**EASTERN TECHNOLOGIES, INC.**

SUBJECT: License Number 01-30362-01 03036499

Enclosed are the updated drawings that are applicable to EIT's facility that we propose to locate at 3114 Point Township Drive, Northumberland, Pennsylvania 17857. The request to change our current license's address to this new location was submitted in an earlier correspondence.

PROJECT			
Pennsylvania Facility			
TITLE			
LRS Collection and Filtration			
DATE	CLASS CODE	ISSUE NO.	PROJECT NO.
			PP0005
DRAWN BY		SHEET 1 of 1

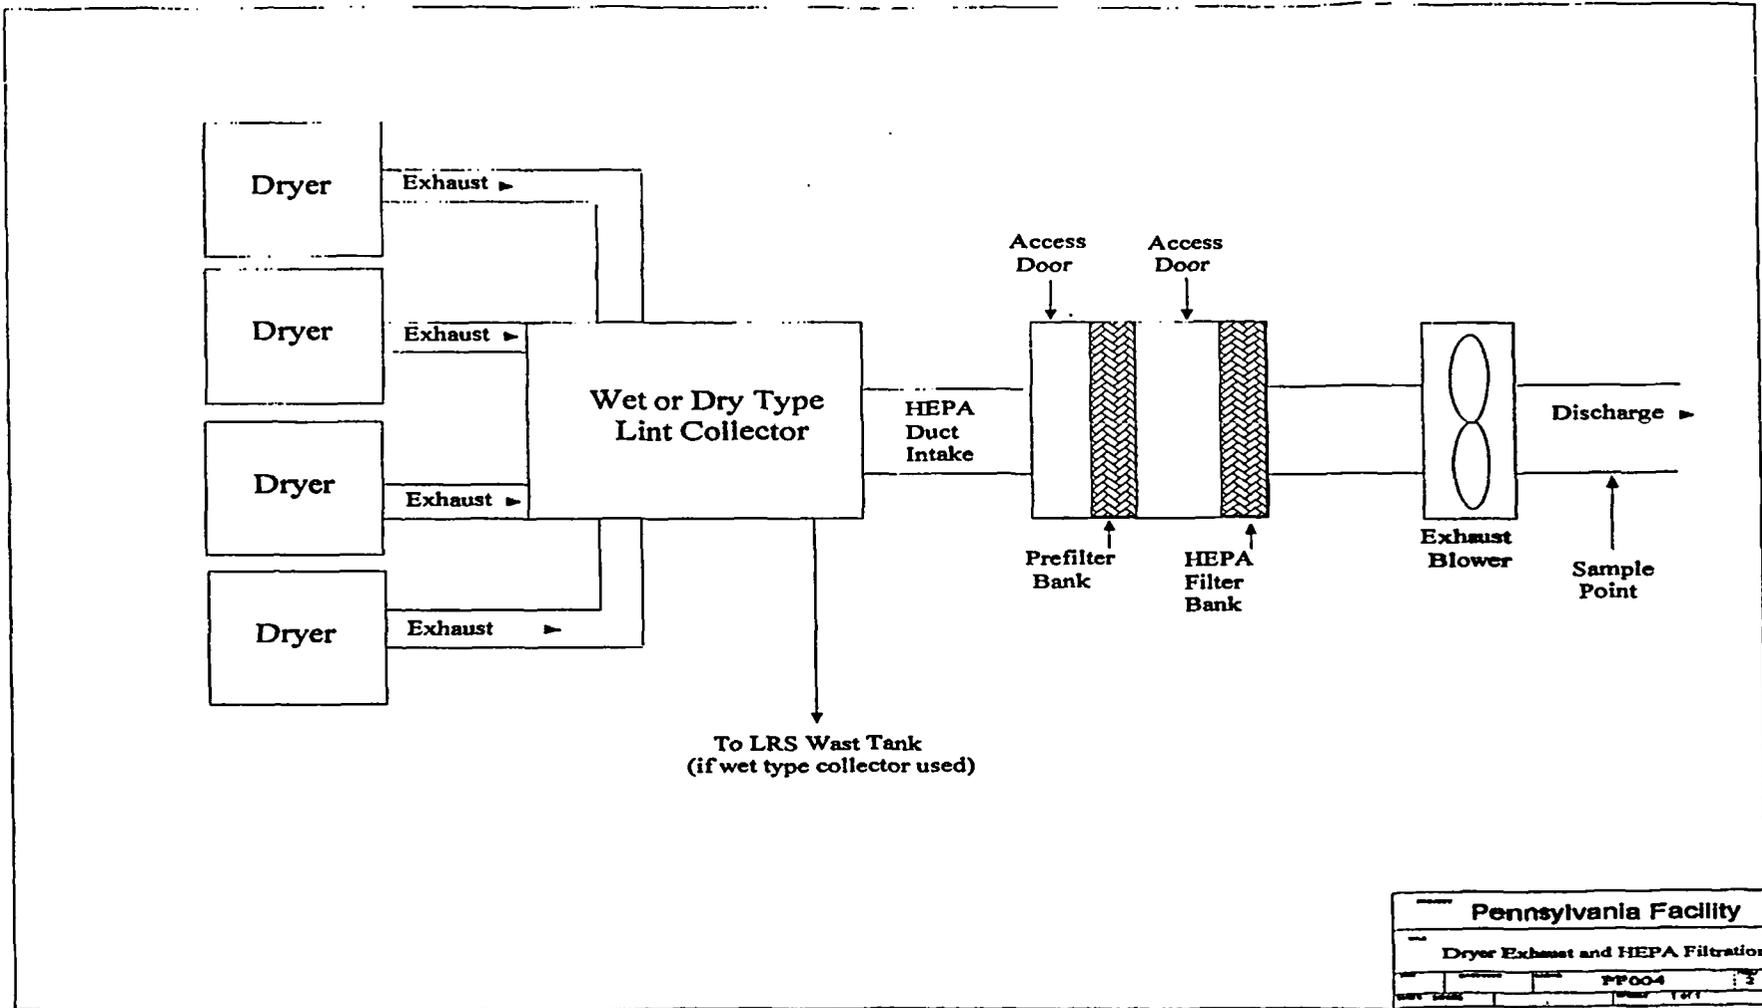
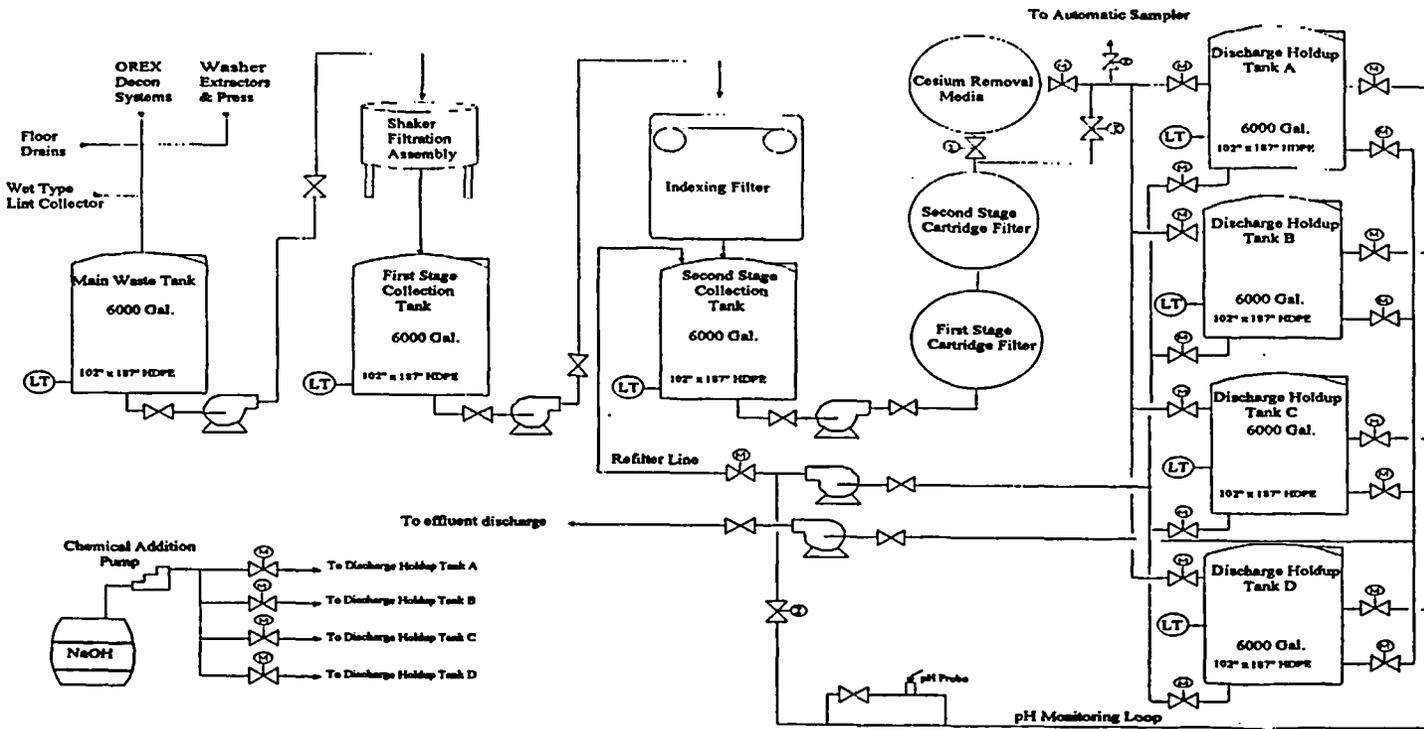
Although this new design is shaped differently than our previous submission there has been no degradation in radiological controls or safety. In addition, some safety controls have been increased. The most notable of the changes is the volume of the water processing containment area and the reduction in size of the waste water holding tanks from 10,000 gallons each to 6,000 gallons each. This change significantly reduces even further the chance of an unmonitored release from the facility.

One other change that ETI has made note of in the plans is the possibility of using a dry type lint collector to accumulate lint and debris exiting the dryers prior to it reaching the pre-filtration section of the Dryer Exhaust HEPA Filtration System. The original submission detailed only the possibility of using a wet type lint collector for this activity. If used the dry type lint collector will operate much in the same way as the wet type lint collector except that it will use filtration screens to trap the larger lint particles as opposed to water. These screens are automatically cleaned by the lint collector and the accumulate debris deposited into a collection receptacle.
